CORRIGENDUM

With reference to our Tender ID No. 2021_CSIR_82286_1 released on 20-July-2021 towards Procurement of CNC Servo Hydraulic Press Brake with Accessories, the below Technical spec is added:-

SKETCH EXPLAINING THE OPEN HEIGHT OF PRESS BRAKE
ANNEXURE - 1A

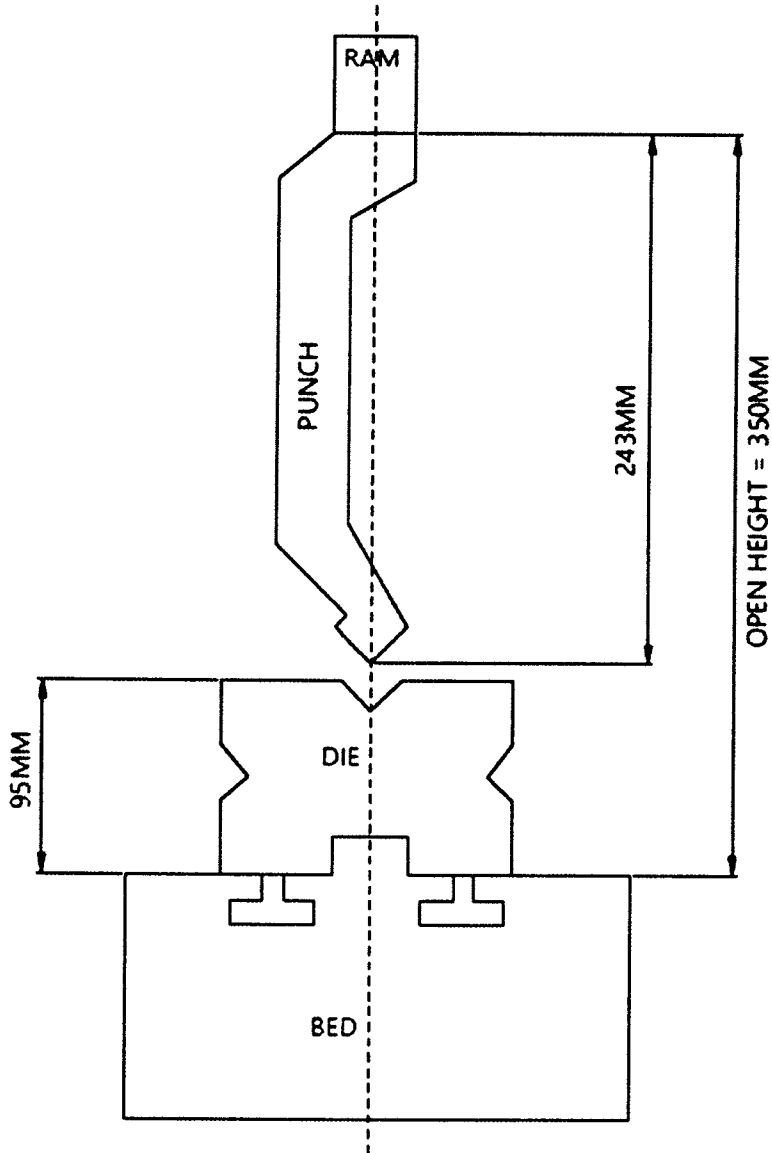
Chapter 4/ Sl. No. 4.2 (C 7)	Open Height - 350mm or more	The Open Height of 350mm or more is calculated as follows: 1. Punch ht: 243mm 2. Die Height is 95mm 3. (Sl. No.1 + Sl. No.2) = 338mm 4. 338mm + 4mm sheet thickness = 342 mm 5. Hence, the Open height is considered as 350mm or more. This is our calculation for arriving at the OPEN HEIGHT value of 350mm. The holder is part of the Press and hence its height is not considered. Refer the Sketch "ANNEXURE – 1A"
Chapter 4/ Sl. No. 4.2 (N 1)	PROVE OUT COMPONENTS AT SUPPLIER'S PLACE: The vendor shall fabricate 1(One) sets of the components as per the drawings enclosed in ANNEXURE-2 . All the necessary tooling/Jigs and Raw material required for Proving out the components shall be arranged by the Vendor	The Components as mentioned in the ANNEXURE-2 shall be fabricated – 1 set as part of the prove out. a. The necessary tooling/Jigs and Raw material required for Proving out the components shall be arranged by the Vendor b. This is not included in the scope of machine supply.
